Technical Service Bulletin

01 MIL on (DTC P310B, P129F, P008B, P129E, P008A, P2540, P0087)

01 14 57 2015106/9 January 9, 2014. Supersedes Technical Service Bulletin Group 24 number 11-06 dated December 7, 2011 for reasons listed below.

Model(s)	Year	VIN Range	Vehicle-Specific Equipment
All	2005 - 2008	All	2.0 TFSI engine 3.2 V6 FSI engine 3.6 V6 FSI engine 4.2 V8 FSI engine 5.2 V10 FSI engine

Figure 2. Pressure sensor

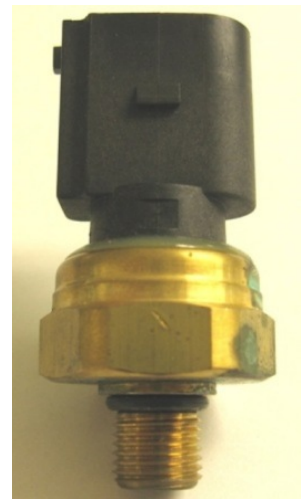
1. Replace the G410 low-side fuel pressure sensor (Figure 2).

2. Clear DTCs and verify that the problem was eliminated.
3. Run Basic Settings 103 to adapt system.
4. Do not replace the high pressure fuel pump, electrical fuel pump, fuel pump control module or fuel filter unless problem persists and further diagnosis indicates a malfunction of any of these components.
